# ITB 18-089

## Tryon Road Sidewalk Addendum #1

Tryon Road Sidewalk WALK 16-113  
Pre-Bid Meeting

CITY OF BROOKHAVEN  
PUBLIC WORKS DEPARTMENT  
GRANITE CURB DETAIL

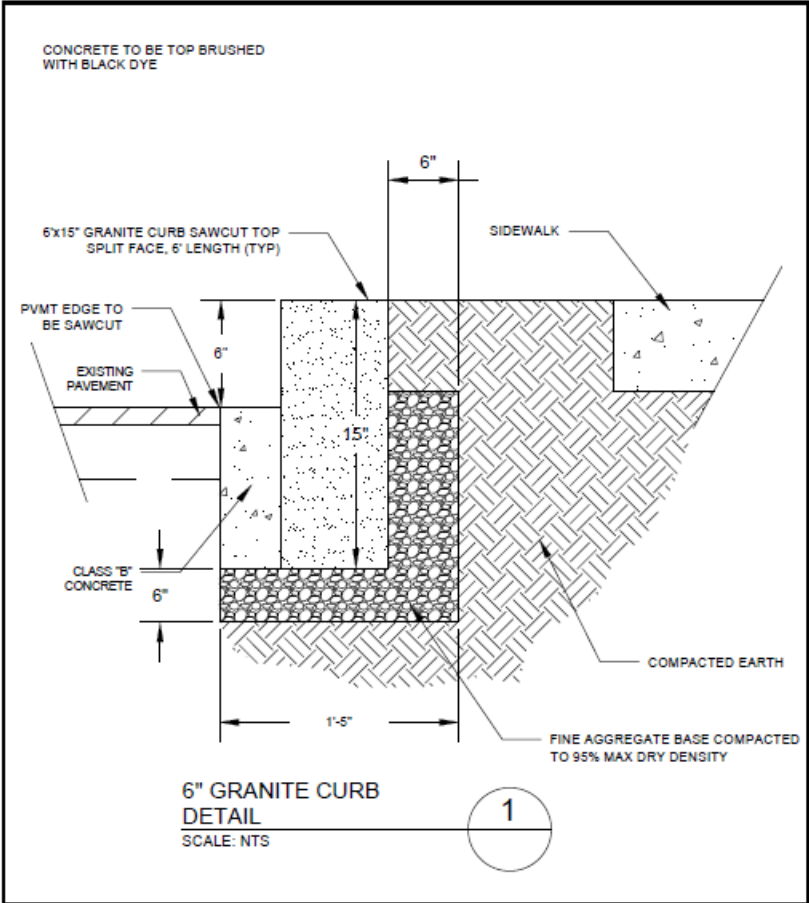
Does the Contractor need to raise the curb?

**Yes. All granite curb is to be raised to allow a 6" reveal. Please see attached detail.**
